REQUEST FOR PARTICIPATION IN THE PATENT PROSECUTION HIGHWAY (PPH) PILOT PROGRAM BETWEEN THE (1) JPO OR (2) UKIPO, AND THE USPTO

Application No.:	10/529,186	First Named Inventor:	Nicolas Goujon
Filing Date:	Oct. 7, 2003	Attorney Docket No.:	14.0210-PCT-US
Title of the Invention:	MULTI-PART SEISMIC CABLE

Patents Act 1977: Examination Report under Section 18(3)

Examination Report under Section 18(3)

United States Patent [19][11] **Patent Number:** 5,265,066

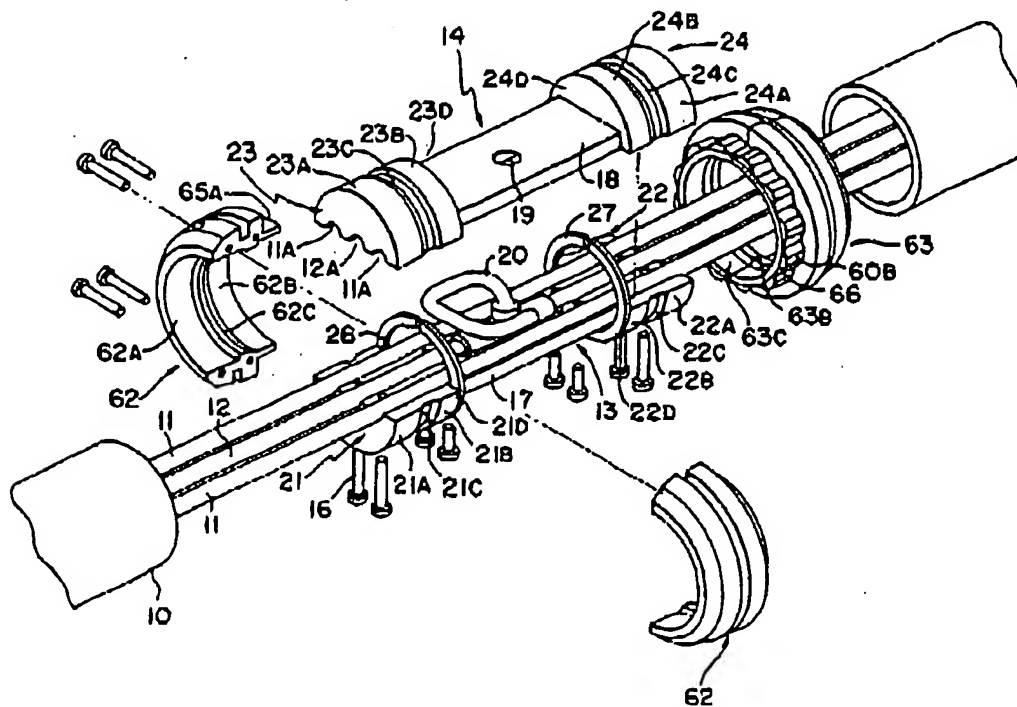
20. US 5,265,066 shows a seismic cable which comprises pulling cables 11 and a data cable 12, as shown in figure 3 and 5. Along the cable are provided cable spheres 6, as shown in figure 1A, each of which include geophones 51,52,53 and an inclination meter 55. I consider the pulling cables, data cable and cable spheres to correspond to the support cable signal cable and sensor modules respectively in your claims. Independent claims 1 and 29 lack novelty in view of US 5,265,066.

21. Figure 3 shows that the seismic cable of US 5,265,066 includes a protective sleeve 10 provided to enclose the pulling cables 11 and the data cable 12. This shows lack of novelty in claims 2 and 3.

25. Figures 3 and 5 of US 5,265,066 shows that claims 24-26 lack novelty. The sensors in each of the cable spheres 6 are connected to the data cable 12 by a connecting wire 20.

2,923,916

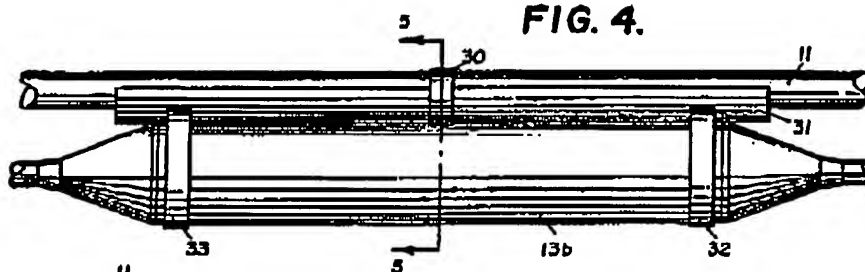
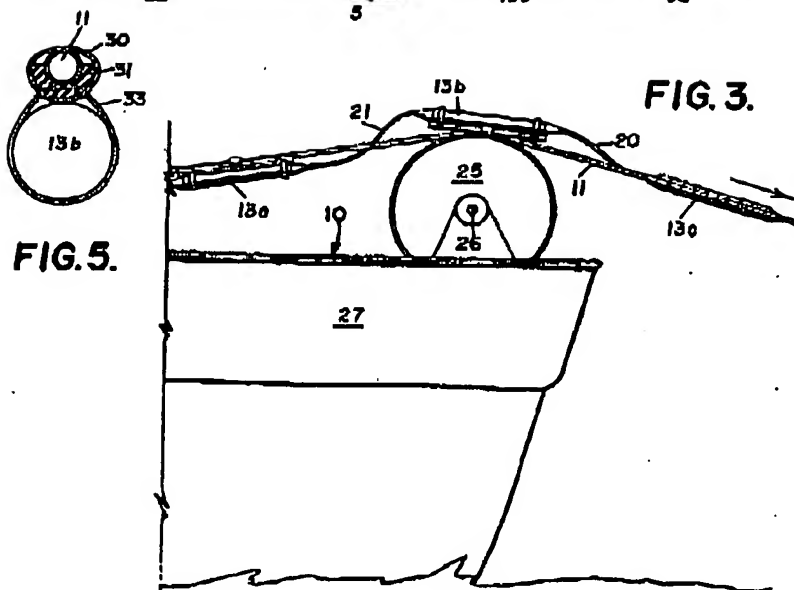
2. Figures 2-5 of US 2,923,916 show a marine seismic cable having a number of seismic detectors disposed thereon. As described at column 2 lines 5-8, a the cable 11 includes strain element. I therefore consider the cable 11 to be a support cable. The seismic sensors 13,14 and 15 are interconnected by a second cable 20, which I consider to be a signal cable. It can clearly be seen from the figures that the signal cable 20 is attached to the support cable 11 at a plurality of points along its length. US 2,923,916 therefore demonstrates that the invention as defined in independent claims 1 and 29 is not new.

5. Figures 2 and 3 of US 2,923,916 clearly show that there are a plurality of sensor modules 13,14 and 15 electrically connected to the signal cable 20, illustrating lack of novelty in claim 11.

6. It appears evident from figure 2 of US 2,923,916 that the points of attachment of the two cables are spaced in proportion to the length of the sensor modules. Claim 16 lacks novelty.

7. Claim 24 is also anticipated by US 2,923,916, as figure 2 shows that the support cable 11 and the signal cable 20 are physically connected together at the sensor modules 13,14,15. Similarly claim 35 lacks novelty.

8. As shown in figure 2 of US 2,923,916 the signal cable and the support cable are separated between the points of attachment. Claim 32 therefore lacks novelty.

[11] Patent Number: 4,884,249
[45] Date of Patent: Nov. 28, 1989

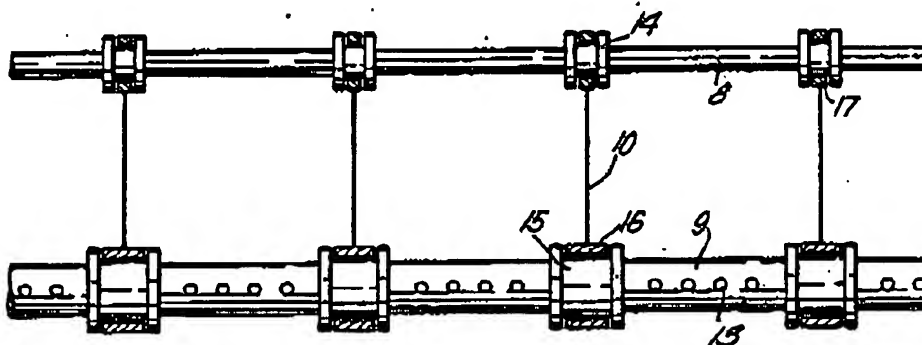
15. Figure 2 of US 4,884,249 shows a marine seismic streamer comprising a floating member 8 which supports, via ropes 10, an active member 9. Though not explicitly stated in the document, it is clear that active member 9 carries a number of seismic sensors,

probably indicated at 13. I consider the floating member 8 to be a support cable and the active member 9 to be a signal cable. US 4,884,249 shows lack of novelty in independent claims 1 and 29.

17. Claim 19 lacks novelty in the light of US 4,884,249 as I consider the ropes 10 to be 'arms'. Since the limitation that the arms are rigid or semi-rigid is introduced in claim 20, I do not consider the term 'arms' in claim 19 to be so limited. Sleeves and rings or swivels 15 and 16 provide rotational connection to the signal cable.

18. Claims 22 and 23 also lack novelty in view of US 4,884,249. The sleeves 15 act as stops restraining movement of the rings 15 along the length of the cable. I consider the sleeve and ring arrangement to be a bearing, in the broad sense of the term.

19. US 4,884,249 also shows a lack of novelty in claim 32 since the signal cable 9 and the support cable 8 are separated between the points of attachment.

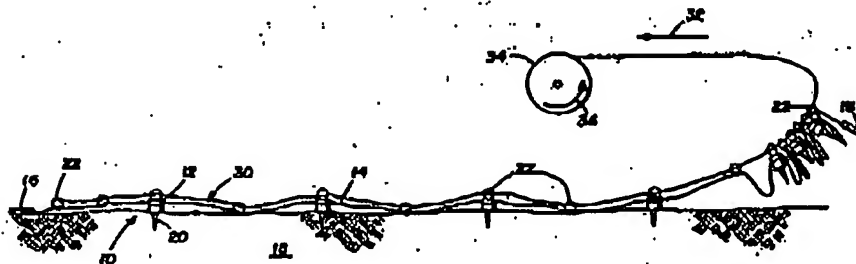
13. Figure 2 of US 4,398,276 shows a seismic cable which has a signal cable 14 which interconnects a plurality of seismic detectors 12. Each detector is attached to a line 30. I consider the line 30 to be a support cable in the sense that it is utilised to pull the sensors out of the ground. The sensors illustrated at the right hand side of figure 2, and their interconnecting cable, are supported by the line 30. This document therefore shows that the invention, as defined in independent claims 1 and 29, is not new.

14. US 4,398,276 also clearly shows lack of novelty in dependent claims 11 and 24.

Fig. 1

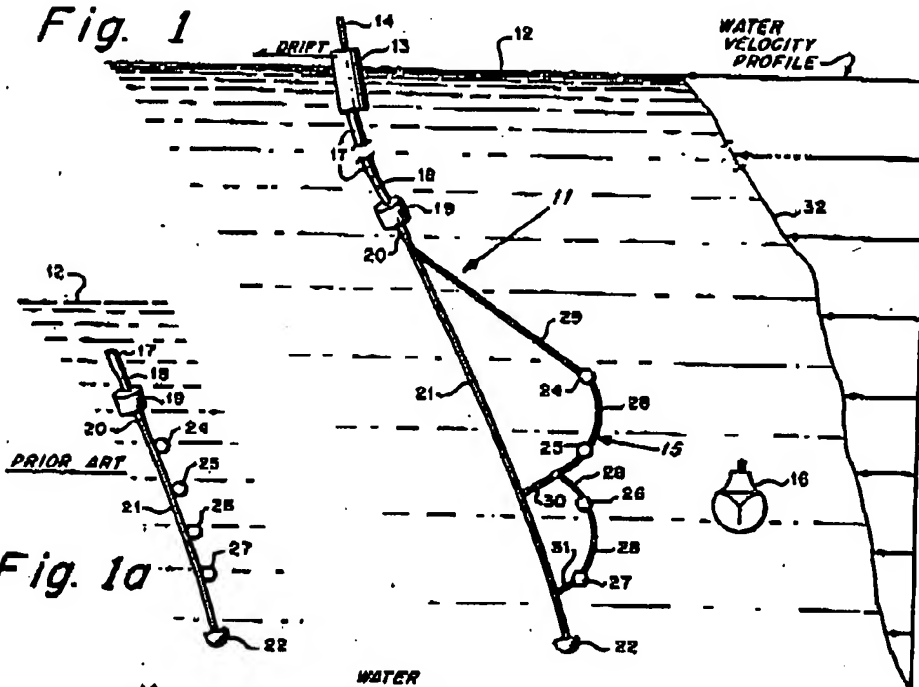
11. Figure 1 of US 3,372,368 clearly illustrates a plurality of sensors modules 24,25,26 and 27 electrically connected to the signal cable 29 through 31. Claim 11 therefore lacks novelty.

12. As shown in figure 1 of US 3,372,368 the signal cable 29-31 and the support cable 21 are separated between the points of attachment. Claim 32 therefore lacks novelty.
